Grid Code Review Panel – Issue Assessment Proforma
Fault Ride Through

GCRP Ref: pp12/04¹

A Panel Paper by John Morris
EDF Energy

Fault Ride Through - Transmission Connected Synchronous Generator

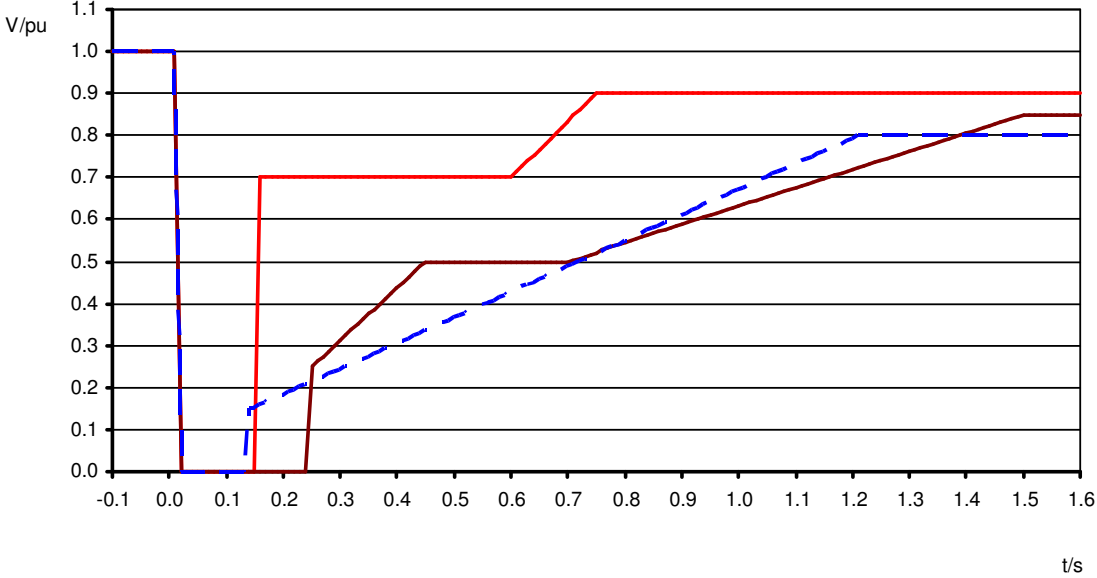
It should be noted that the ENTSO-E draft network code requirements for generators currently includes a modified voltage-duration profile with a minimum and maximum boundaries. The current example voltage dips in CCA.4A.3 for 30% and 50% would not lie within the boundaries defined by Figure 7 in the ENTSO-E draft code for synchronous generators connected at greater than 100kV voltage level. The timetable for adoption of the ENTSO-E requirements may still be protracted and it is suggested that this proposal be considered on its own merits. It would be possible to use the proposed boundaries as the limiting case for any site specific voltage-duration profile if this was deemed necessary by comitology. See attached comparison of ENTSO-E RfG and the current GB Grid Code requirements.
